## Traffic Impact Study

2024-12-15 (DJK) reviewed, comments include:

# QuikTrip 4217

# T R A F F I C   I M P A C T   S T U D Y

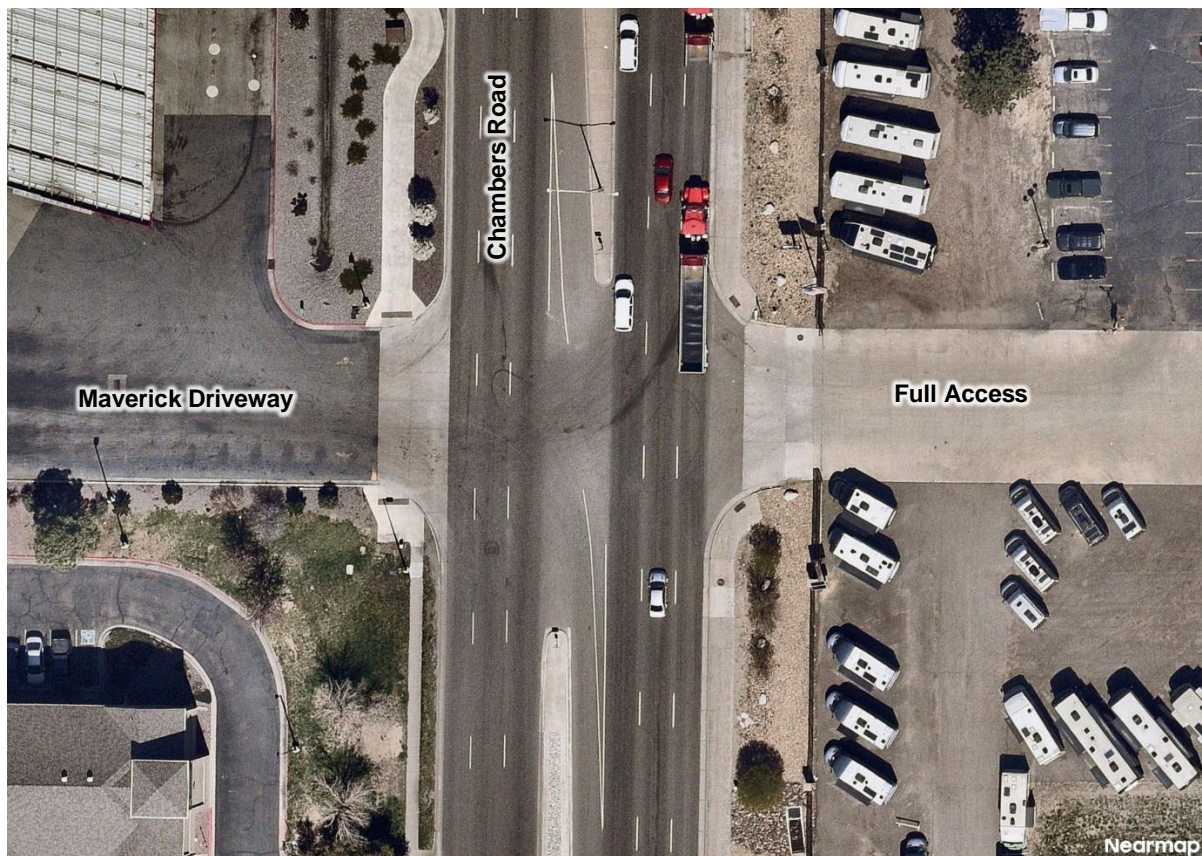
Flowline to flowline I get  
~290', CL to CL I get ~340'

This has been updated  
to better clarify the  
intersection spacing.

*Maverick Driveway / Full Access & Chambers Road (#3)*

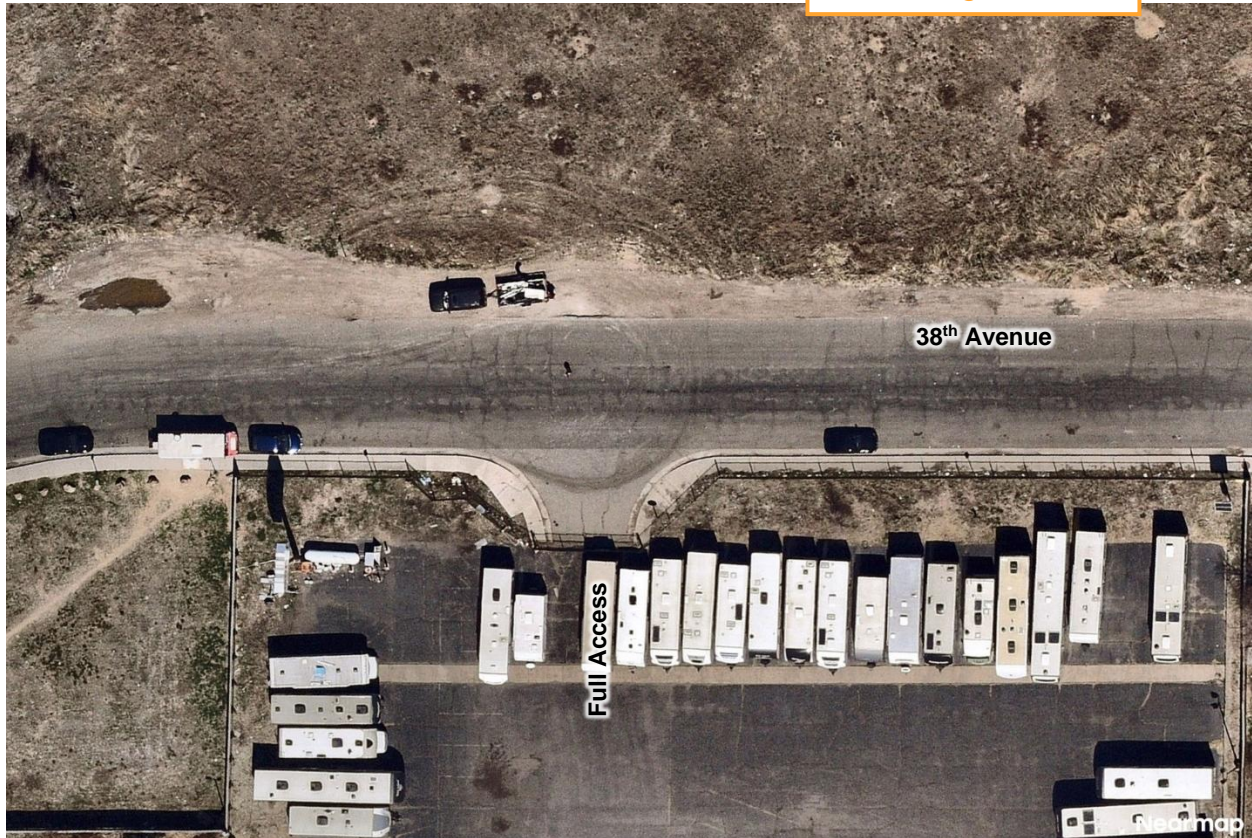
FL to CL

Should mention the access is gated

This has been updated to better clarify the intersection spacing, and additional description regarding its current gated condition has also been incorporated.

FIGURE 2  
 QUIKTRIP 4217  
 AURORA, COLORADO  
 EXISTING GEOMETRY AND CONTROL

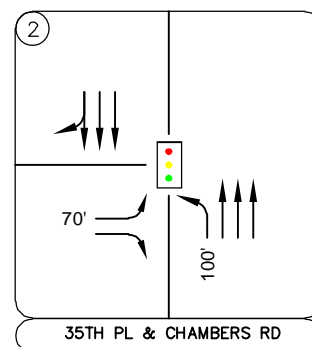
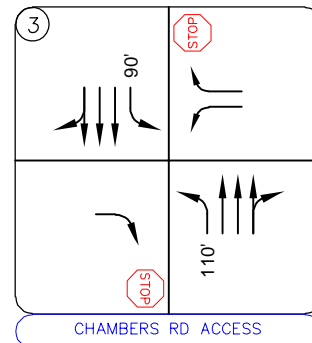
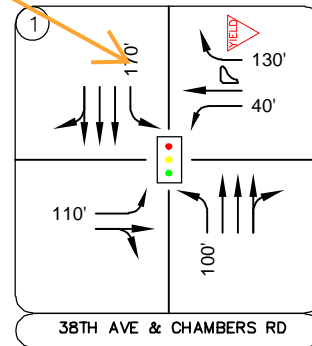
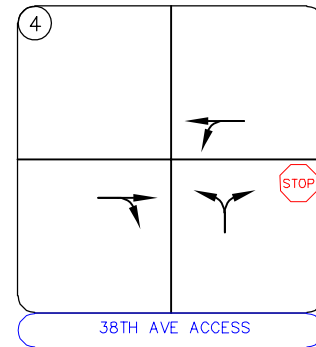
Striped, but median available for 225' total

Agreed, and this has been updated accordingly in the figures and throughout the report where needed.

**FIGURE 6**  
 QUIKTRIP 4217  
 AURORA, COLORADO  
 NON PASS-BY TRIP DISTRIBUTION

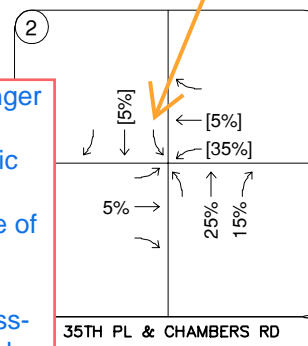
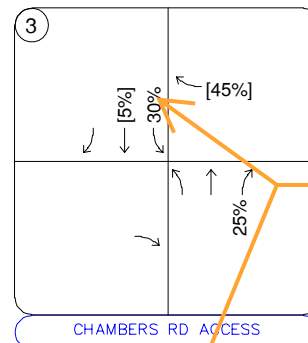
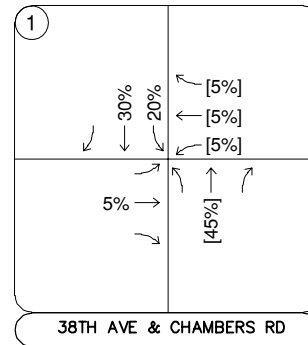
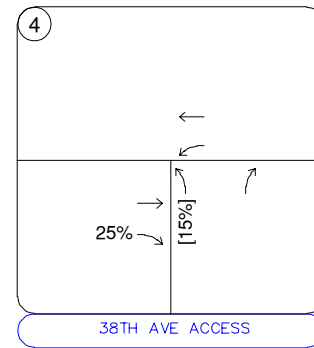
Because of the nature of the site with both the convenience store and passenger vehicle fueling positions located adjacent to this access and the backtracking required if vehicles enter at 35th PI from the north, it is believed most SB traffic on Chambers will desire to enter via the SBL at 38th or at the 3/4 movement access. Despite the high NB volume, because there are signals on either side of this access, this will provide gaps in traffic on Chambers.

Really think this % will fight the high NB traffic volume vs using the signal at 35th?

We have updated the analysis to provide 5% of both the non pass-by and pass-by traffic entering via the signal at 35th PI, however for the reasons mentioned above, it is believed this distribution will be representative of how traffic will arrive to the site from the north.

Additionally, based on the results of the updated analysis, even with this trip distribution assigned to the SBL at the 3/4 access, this amounts to no more than an average of about 1.8 veh/min turning SBL at this access. During peak periods, based on the analysis performed this would not be expected to exceed an average of 50' (about two vehicles) queued for this movement through 2050.

## 1: Chambers Road & 38th Avenue

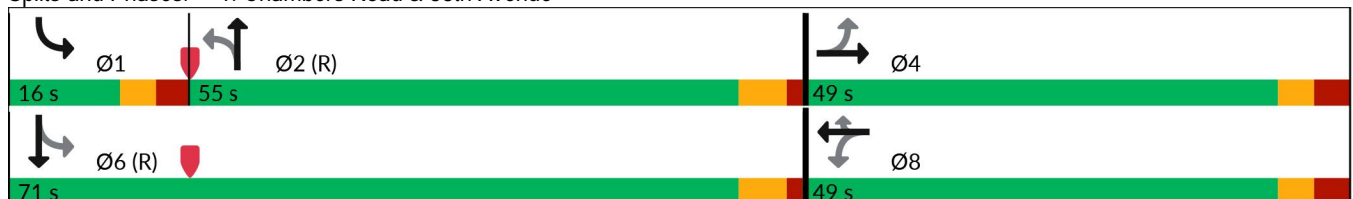
Did you confirm timings with COA Traffic Staff? See attached on next page (140 sec cycle) DRCOG timing seemingly used have not been updated since the controller swap-outs performed earlier this year

As noted previously, the updated signal timings have been incorporated into the study in each scenario and horizon year.
